New Re	eactors Division – Generic Design Assessment
Step 4 Assessment of Cro	ss-cutting Topics for the UK HPR1000 Reactor

Assessment Report ONR-NR-AR-21-007 Revision 0 January 2022

Figure 1: Link between general requirements, schedules, engineering documents and safety functional requirement reports

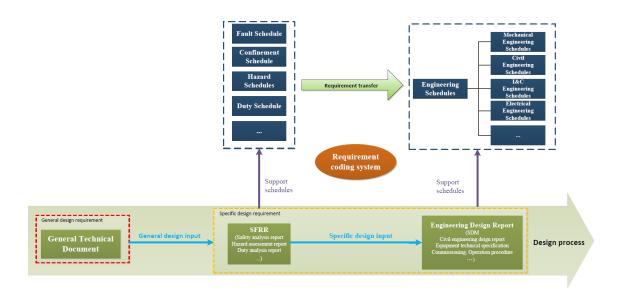
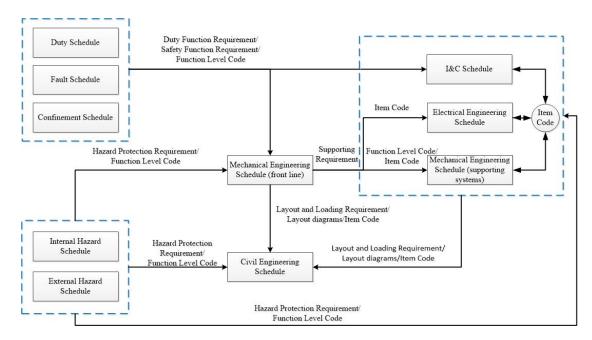
- 153. The requirement coding system applied by the RP is described in the 'Requirements Management Summary Report' (Ref. 16), and is detailed in the RP's requirements management procedure (Ref. 17). It consists of four fields which represent the system or building code, requirement type, serial number and control mode respectively. Through this coding the RP is able to distinguish the identified requirements, and it in itself provides information to aid the user's understanding of the requirement. At this point it is worth noting the second field regarding requirement type. The RP uses this field to distinguish between the functional requirements associated with faults, severe accidents, confinement, duty and hazards schedules. I assess the adequacy of this approach as part of my sample later in sub-section 4.5.1.4, but in principle, I am content that the application of such a coding system is a reasonable approach to identifying and tracing requirements throughout the safety case. The obvious disadvantage to this approach is that it carries a significant administrative burden and could create errors.

Figure 3: Scope of operating rules development during GDA

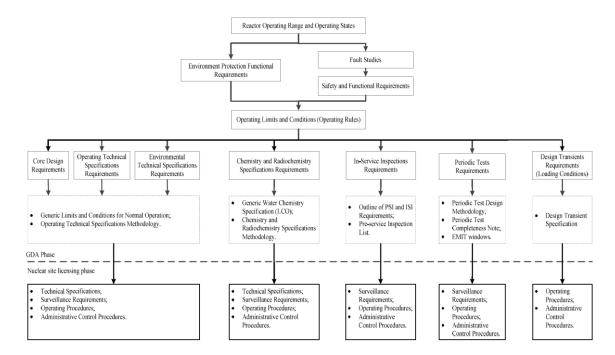
- 218. As seen in Figure 3, the RP considers there to be seven categories of operating rules: OTS, Environmental Technical Specifications (ETS), Chemical and Radiochemical Specifications (CRS), ISI, Periodic Testing (PT), loading condition (design transient) requirements and core design requirements. It should be noted that OTS, ETS and CRS are considered as TS. Figure 3 includes the main types of operating rules I would have expected to see and covers the breadth of operating rules that will need to be developed. I am satisfied that this approach is adequate for GDA.

- 239. As shown in Figure 3, there are some aspects of operating rules that the RP has not developed during GDA. Instead, it has provided methodologies for how a licensee could use the generic safety case information to develop TS, surveillance programmes and operating and administrative procedures. Those aspects not considered earlier in my assessment include:
